16 November 2011

Independent Monitor's Audit Report of the McArthur River Mine for the 2010 Operational Period.

Figure One- A cross section at 2300mN of the MRM Resource Model showing stratigraphy

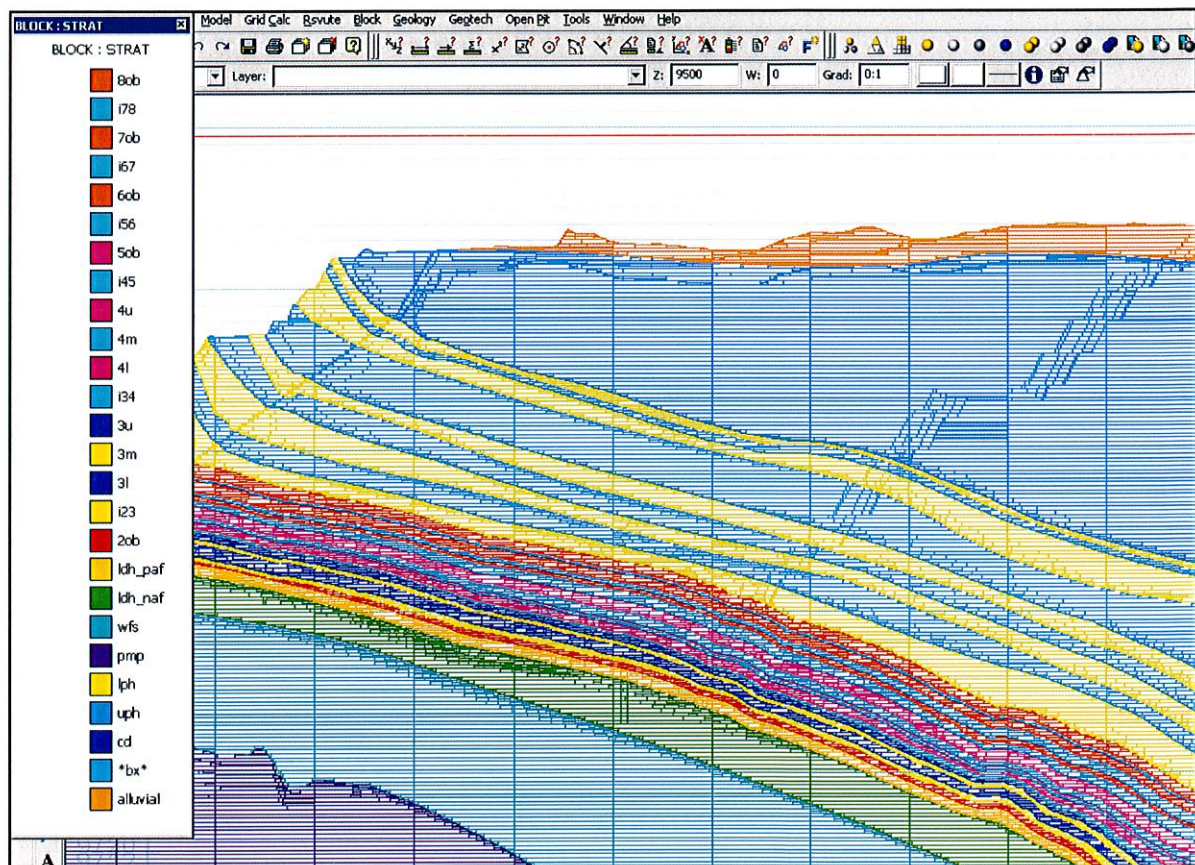
The visual method for classification of NAF/PAF waste rock is of concern as it poses the potential for misclassification

There is significant science and analysis involved in classifying NAF and PAF waste rock.

Waste is characterised through a block model based on drilling information gained from analytical programs that have in the main, been completed since 2002.

Stratigraphic units are identified in the block model based on geological logging and interpretation. Domains or stratigraphic units in the MRM block model have hard boundaries; this means that blocks in the block model are not spread across a boundary or different stratigraphic units; rather a particular block will represent one material type only.

The majority of the footwall stratigraphy (Teena dolomite, W-Fold shale and the Lower dolomitic shale) has been identified as non-acid forming through geochemical waste characterisation testing of drillhole samples. However, the top 5 metres of the Lower dolomitic shale up to the 2 orebody footwall has been re-classified as PAF in the block model as it contains 1.5 -2 metres of the strongly sulphidic #1 orebody and 1.5 metres of pyritic shale.

For PAF classification of the more heterogenous hangingwall sequence, the *hw_paf_2009.bcf* codes the paf variable with the same integers as above based on interpolated Fe and final NAG pH content derived from 5 metre length composites sampled during the 2002 and 2007 waste characterisation drilling campaigns. e.g. For fresh material: if, for a particular block the Fe grade is >7.5% and the pH is < 4, this block is coded with PAF = 9, which means the block is classified as PAF. For fresh material: if, for a particular block the Fe grade is <7.5% and the pH is > 4, this block is coded with PAF = 3, which means the block is classified as NAF.

The block model is used as the basis for identification of NAF and PAF by the Pit Technicians. This is followed by a visual check once the material is blasted and as it is being dug to ensure the classification is accurate to what has been actually revealed. Based on the combination of this information, material is ultimately classified by the Pit Technician and sent to the appropriate location at the NOEF.

Figure Two- Topsoil locations at the Northern OEF

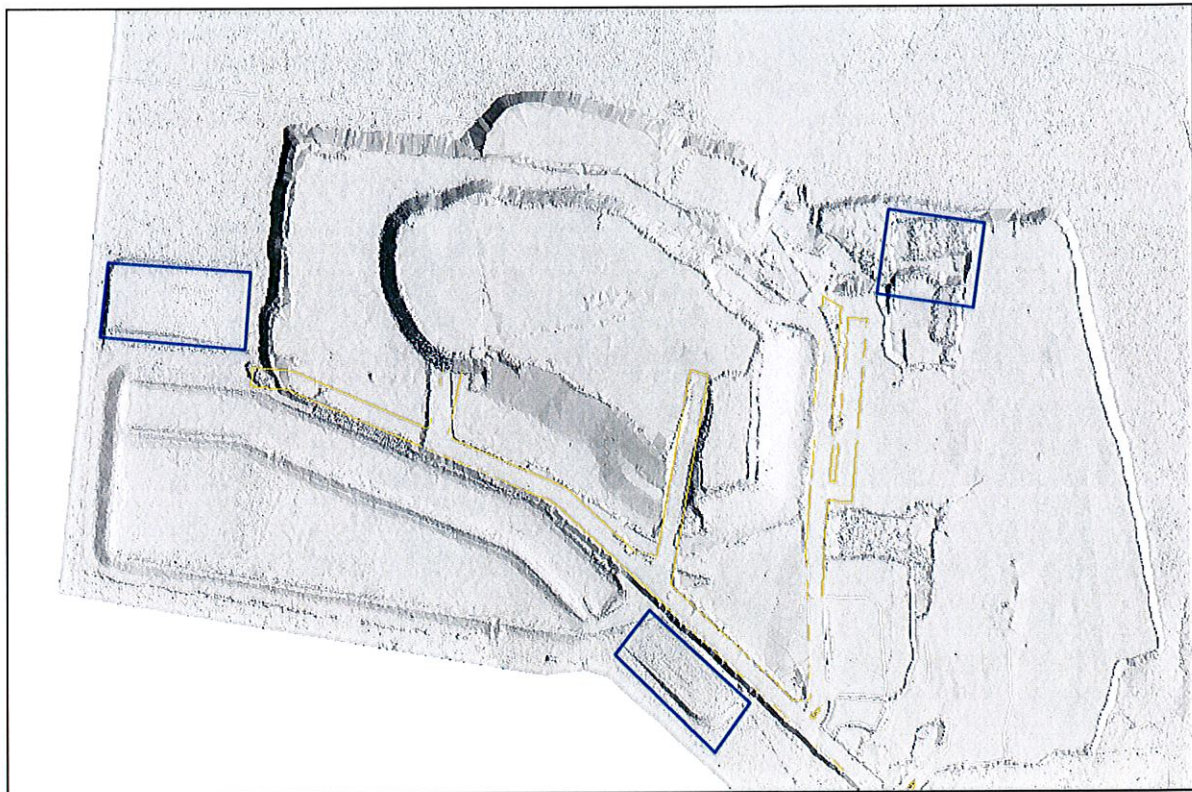
The report states that topsoil stockpiles are not enough for rehabilitation of the tailings dam or waste dump. This is incorrect.

Topsoil for the TSF is stored in a stockpile to the north of cell two. Topsoil for the OEF is marked in locations on the following map.

Topsoil is currently stockpiled in three locations at the NOEF. Topsoil is stripped from the ground to expose a clay layer prior to placing a NAF base. Generally up to 300mm of topsoil is removed. The survey pick up of the NOEF as shown below shows the stockpile locations (highlighted in blue).
